DEVELOPMENT REVIEW BOARD PANEL B AGENDA

2. **Resolution No. 441. ParkWorks.** The applicant is requesting approval of a Class 3 Sign Permit, Waiver, and Site Design Review for the installation of a 355-square-foot wall sign and a mural on an industrial building visible from SW Parkway Avenue and Interstate 5.

DB25-0002 ParkWorks

Exhibit A1
Planning Division Staff Report
Class 3 Sign Permit and Wall Mural for ParkWorks

Proposed 355 sq. ft. sign

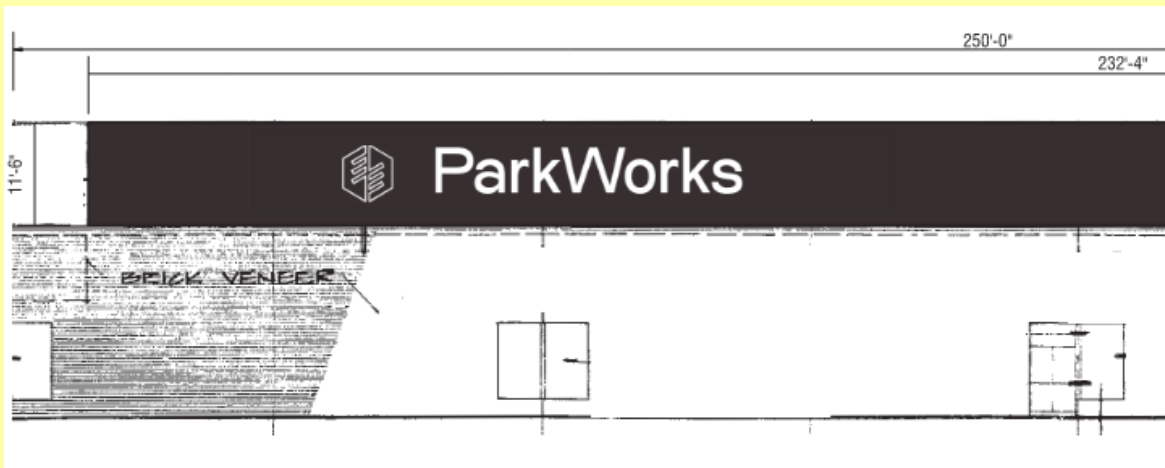
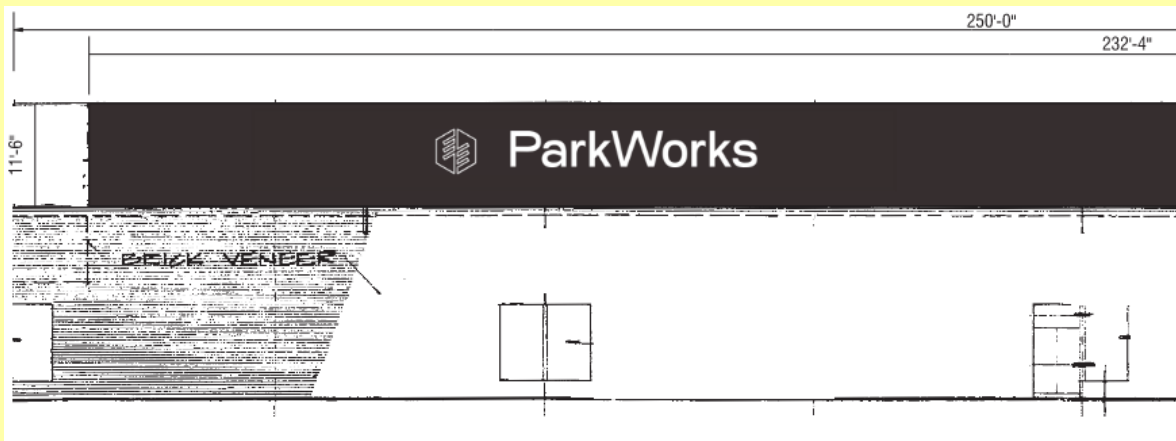
The applicant proposes a 355 sq. ft. wall sign appropriately placed within the parapet of the west façade, addressing the requirement that wall signs are located within a definable architectural element. The parapet is roughly 11.5 ft tall. The sign lettering and logo vary in height. The logo is the tallest portion of the sign measuring slightly above 8ft. The lettering is between approximately 5 ft and 6.5 ft in height. With the sign centered between the top and bottom edge of the parapet, the amount of definable space provided between the sign and edges of the architectural feature ranges between 1.75 ft and 3.25 ft. Regarding both readability and complementary design, the larger a sign is in relation to the architectural feature in which it is placed the more definable space is needed to provide balance between the positive and negative space. While the definable space provided with the proposed wall sign may be adequate in relation to a larger less constrained architectural feature or a smaller sign, the large sign looks cramped within the parapet and would detract from the design of the building. A Condition of Approval limiting the sign to 200 sq. ft. will enable the applicant to create more significant definable space above and below the sign so it is not constrained by the parapet and instead appears to be a natural and balanced addition to the building, complementing and drawing positive attention to the architecture. See the images below demonstrating the appearance of the sign at 355 sq. ft., 200 sq. ft., and 132 sq. ft.

The three images above demonstrate how the relationship between the size of the sign and the architectural feature in which they are placed changes the visual impact of the sign. In the first image the 355 sq. ft. sign dominates the parapet and does not appear to be balanced. Whether there is sufficient definable space is questionable as the sign appears to be “pushing” against the upper edge of the parapet.

| PDA 1. | Ongoing: The approved sign shall not exceed 200 sq. ft. and be installed in a manner substantially similar to the sign approved by the DRB and stamped plans approved by the Planning Division. |

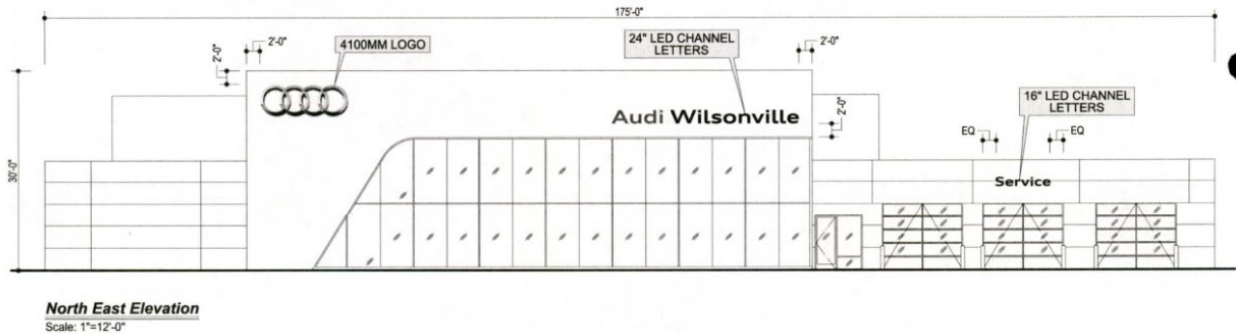
The Audi dealership located to the west of ParkWorks, across I-5, at 26750 SW 95th Avenue is again a comparable example of wall signs in the area. Similar to the ParkWorks development, the Audi dealership's northwest facade is visible but setback from I-5 and the parallel street, Boones Ferry Road. The northwest façade includes two wall signs totaling approximately 200 sq. ft. The two signs are placed thoughtfully in relationship to the building architecture with appropriate space between the edges of the façade and glazing elements, creating a clean look with a definable space specific to the sign. Since the 200 sq. ft. allowance is broken up between the two signs the appearance of the signage does not overly dominate the façade. While there is only 2ft between the signs and the edges of the architectural features they are placed within, the simple design of the façade which prevents the signs from feeling cramped or inappropriately placed. While the edge

of the Audi logo is framed by the roof line and south edge of the façade on two sides, the other two sides are unrestricted, creating a feeling of openness. Similarly, the “Audi Wilsonville” portion of the sign is framed by the glazing and north façade on two sides, while the other edges of the sign remain open. See the design and location of the signs as included as a part of Audi’s sign adjustments, AR10-0017, below:

Proposed 355 sq. ft. sign

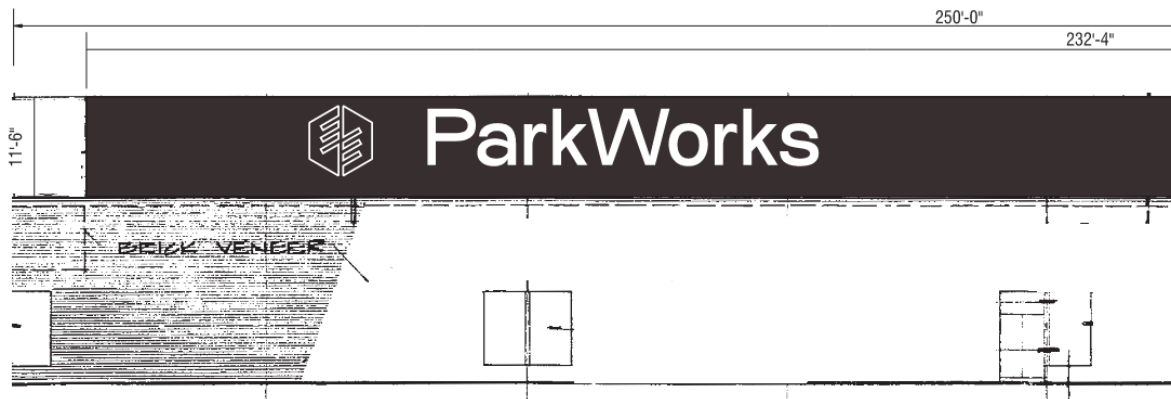
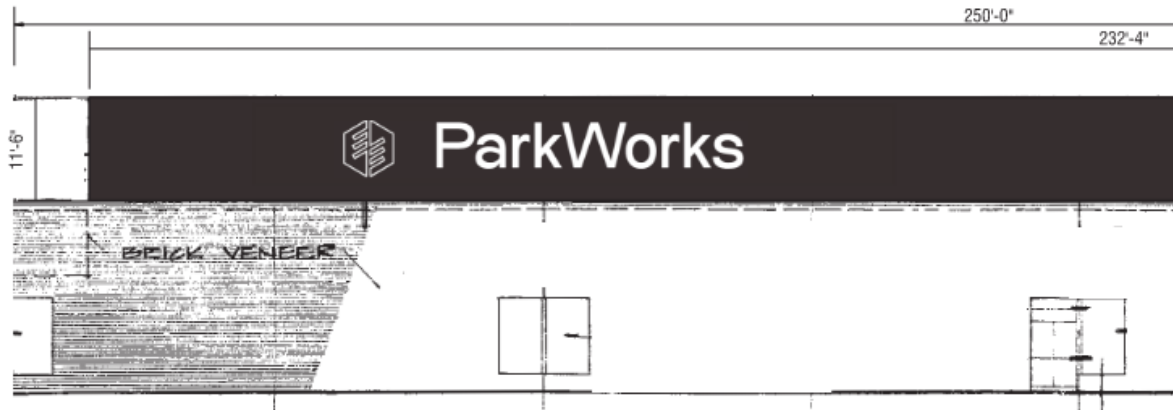
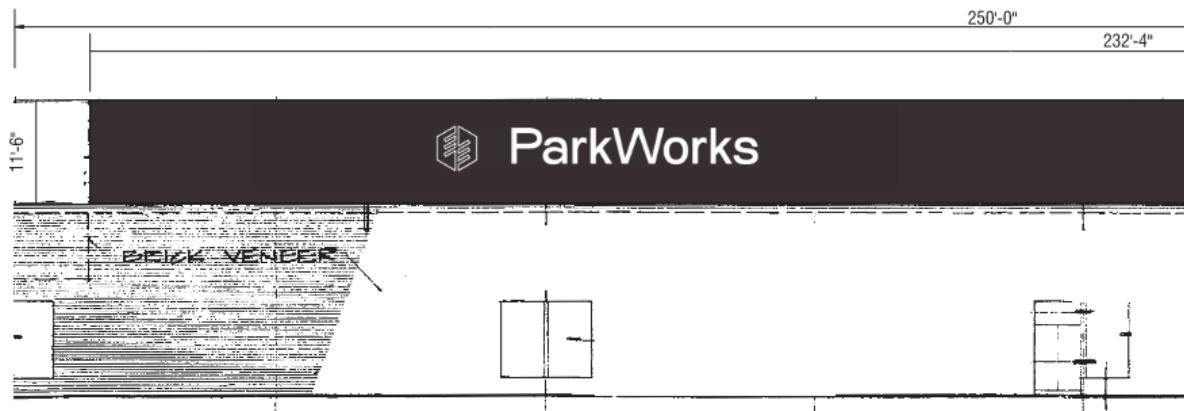
As mentioned above, the 355 sq. ft. sign does not allow for appropriate definable space between the sign and the edges of the parapet. Staff completed an analysis with mockups demonstrating the visual impact of providing appropriate definable space as it relates to the architectural feature in which the ParkWorks sign is proposed. See the images below demonstrating the appearance of the sign at 355 sq. ft., 200 sq. ft., and 132 sq. ft.

The three images above demonstrate how the relationship between the size of the sign and the architectural feature in which they are placed changes the visual impact of the sign. In the first image the 355 sq. ft. sign dominates the parapet and does not appear to be balanced. Whether there is sufficient definable space is questionable as the sign appears to be “pushing” against the upper edge of the parapet creating a constricted feeling.

However, a 355 sq. ft. sign would be dominating and out of sync with the architecture of the building. Limiting the sign to 132 sq. ft. also calls into question whether balance between the wall sign architectural feature can be achieved. The parapet provides natural boundaries for the sign to fit within. The smaller sign results in more negative space surrounding the sign. A balance should be struck between the need to fill the architectural feature and the requirement that the sign is complementary and compatible with the building's design. The sign should fit snugly but not appear cramped. For that reason, staff recommends a Condition of Approval limiting the sign to 200 sq. ft. . See Findings A5 and A10. for an in-depth analysis of the signs compatibility in relation to size and placement within the buildings architectural features.
